GD 4350

Pneumatic packet hopper

Replacement of the refill packet hopper with a pneumatic hopper

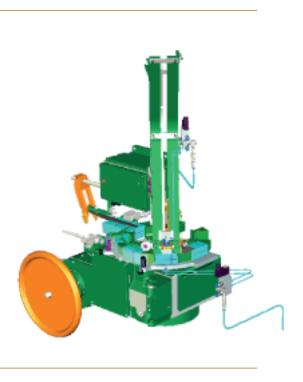
Issue

Quality issues with film appearance caused by abrasion between packets within the hopper and packets in the exit wheel

Improve packet quality through reduced abrasion with a pneumatic packet hopper

- Consequences Non-conforming product
 - Integration of pneumatic hopper
 - Pneumatic hopper creates space between the last packet in the hopper and the packets transferred to the exit wheel

- Integration of pneumatic hopper and packet lifter
- Approx. machine down time: 10 hours
- Total mechanical hours: 16 hours
- Total electrical hours: 16 hours
